DESIGN <b>PH</b>	DRAWN BY <b>CB</b>	DART AEROSPACE LTD HAWKESBURY, ONTARIO, CANADA	
CHECKED <b>PH</b>	APPROVED <b>[Signature]</b>	DRAWING NO. DSI 9328	REV. B SHEET 1 OF 1
DATE 07.03.07		TITLE RUN-ON LANDING WEARPLATE KIT	SCALE NTS
A	06.04.20	NEW ISSUE	
B	07.03.07	AMEND PARTS LIST

## DART SERVICE INSTRUCTION

TO AMEND INSTALLATION INSTRUCTIONS D205-564 Rev. D / IIN-D430-688 Rev. B

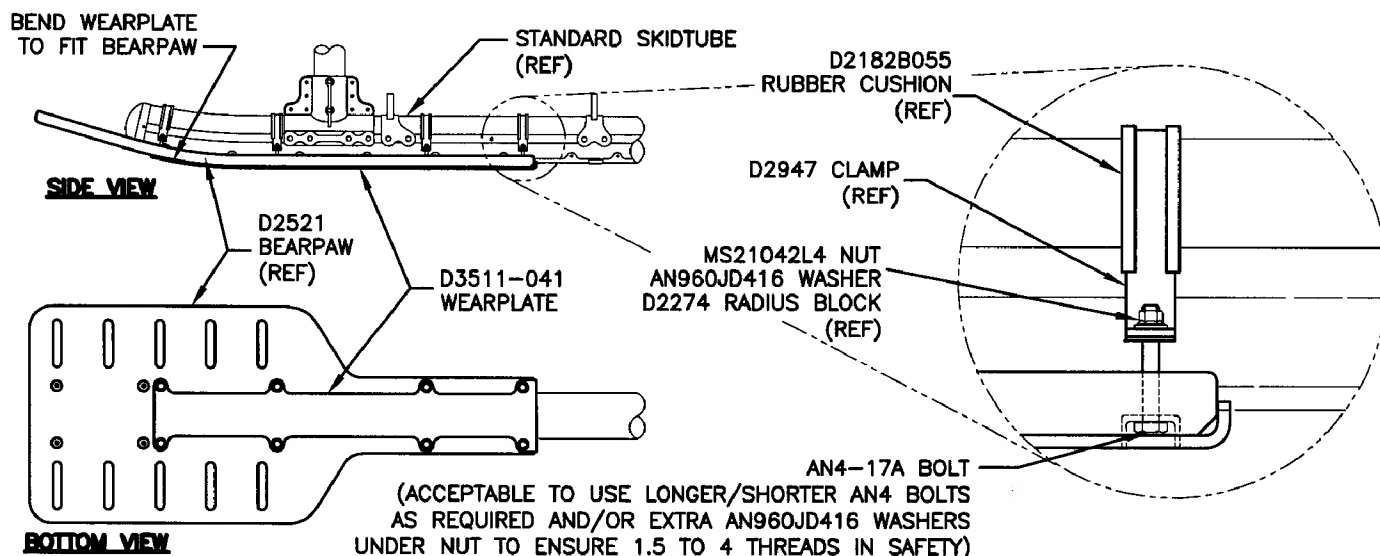
The DSI-9328-011 Run-on Landing Wearplate Kit can be installed on Dart D205-564-011 at CHG 006 or later or D430-688-011 Bearpaw Installations at CHG 002 or later only. Earlier model bearpaws can be made compatible with DSI-9328-011 kit by opening up counter bores to Ø0.930. The wearplate kit includes two stainless steel wearplates that fit to the bottom of the Dart Bearpaws. Install the wearplates as shown below. Note that the D2529 washers are not required when the D3511-041 wearplates are installed.

TORQUE ON THE NUTS SHOULD BE LIMITED TO 20 in-lbs
